Abnormal ("Squeak") Noise From Rear Suspension Over Uneven Road

Service Category Suspension

Section Rear Suspension

September 21, 2016 Rev1:

Figure 1.

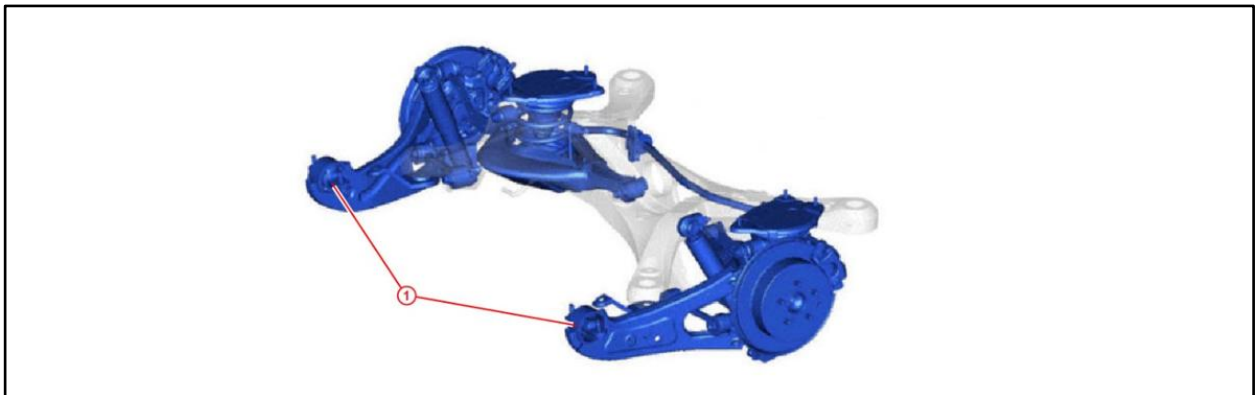
Some 2014 model year Highlander and Highlander HV vehicles may exhibit an abnormal noise, like a "squeak/squawk/groan" type noise, from the rear suspension when traveling over uneven roads which may become more pronounced in colder ambient temperatures. The abnormal noise may be caused by the Rear Trailing Arm bushing. An updated Rear Trailing Arm Assembly is available. Follow the Repair Procedure in this bulletin to address this condition.

- **YES** — Go to step 3.
 - **NO** — This bulletin does NOT apply. Continue diagnosis using the applicable Repair Manual.
3. Replace BOTH Rear Trailing Arm Assemblies even if only 1 side is emitting the "squeak/squawk/groan" type noise.
